ECE/TRANS/WP.29/GRB/2006/6
23 June 2006

PROPOSAL FOR DRAFT AMENDMENTS TO REGULATION No. 51

(Noise emissions)

Submitted by the expert from the International Organization for Standardization (ISO)

Figure 1: Reference point

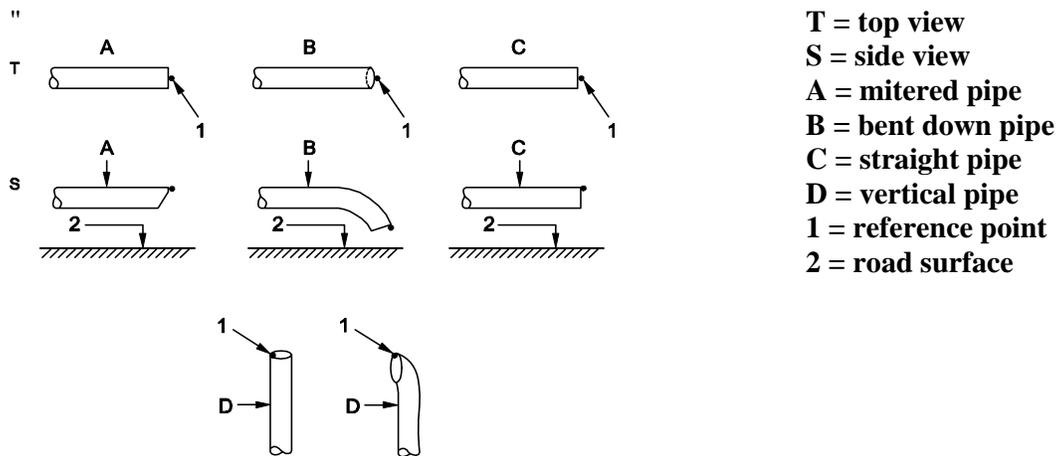
Appendix, figures 1 and 2, amend to read:

ISO proposes to amend figures 1 and 2 in order to align them with ISO/DIS 5130.

Figure 2b

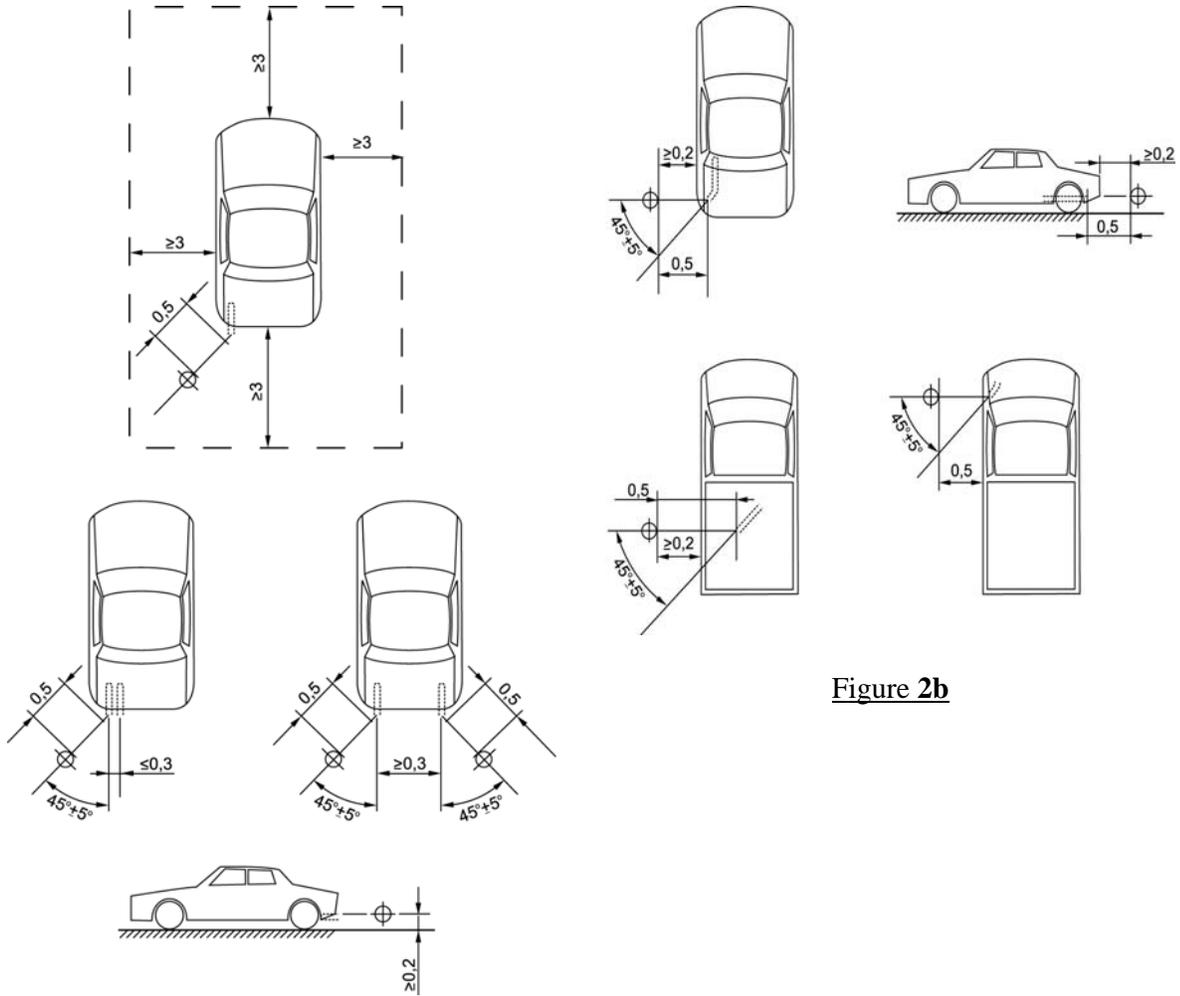
"3.2.5.3.1.6. For vehicles, **where the reference point of the exhaust pipe is not accessible, or located under the vehicle body, as shown in figure 2b and 2c, because of the presence of obstacles which form part of the vehicle (e. g. spare wheel, fuel tank, battery compartment), the microphone shall be located at least 0.2 m from the nearest obstacle, including the vehicle body, and its axis of maximum sensitivity must face the exhaust outlet from the position least concealed by the above-mentioned obstacles.**"

Note: Figures from 2a to 2d show examples of the position of the microphone, depending on the location of the exhaust pipe."

Figure 2c

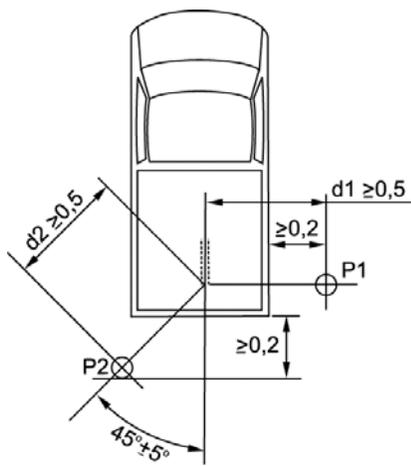
"**3.2.5.3.1.7. When several positions are possible, as shown in figure 2c, the microphone position giving the lowest value of d1 or d2 shall be used.**"
